**ALERT SERVICE BULLETIN**

**NO.** 407-08-83

**MODEL AFFECTED:** 407

**SUBJECT:** HYDRAULIC PUMP DRIVESHAFT ASSEMBLY  
406-040-072-105, ONE TIME INSPECTION OF.

Figure 1. Hydraulic pump driveshaft assembly

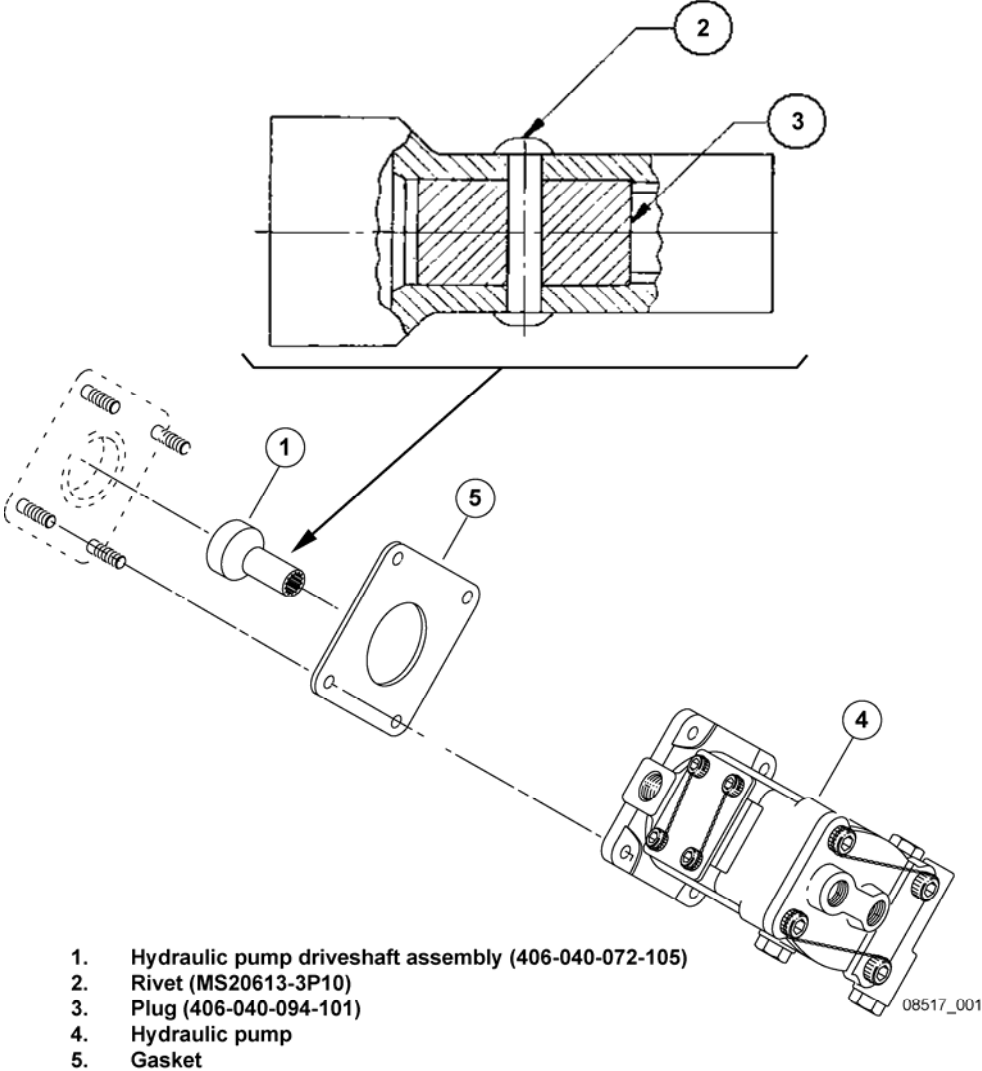
Bell Helicopter has received reports of hydraulic pump driveshaft assemblies 406-040-072-105 that may have been delivered with missing internal plug or fastening rivet. This condition could lead to a loss of hydraulic pressure.

1. Inspect hydraulic pump driveshaft assembly (1, Figure 1) for missing rivet (2) or plug (3).
2. If rivet (2) or plug (3) is missing, submit a completed MMIR to BHTI Warranty Department and order parts listed in the MATERIAL section of this bulletin.
3. If rivet (2) or plug (3) is not missing, attach a serviceable tag to the hydraulic pump driveshaft assembly (1) and write "THIS HYDRAULIC PUMP DRIVSHAFT ASSEMBLY COMPLIES WITH ASB 407-08-83".

1. Remove hydraulic pump driveshaft assembly (1, Figure 1). Refer to BHT-407-MM-4, Chapter 29.
2. Inspect hydraulic pump driveshaft assembly (1) for condition and missing rivet (2) or plug (3). Refer to figure 1 and BHT-407-MM, Chapter 29.

3. If rivet (2) or plug (3) are missing proceed as follow:
  - a. Submit a completed MMIR to BHTI Warranty Department.
  - b. Obtain parts listed in the material section of this bulletin and comply with TB 407-01-30 Rev A.
4. Make an entry in the helicopter records to indicate that this bulletin has been accomplished.
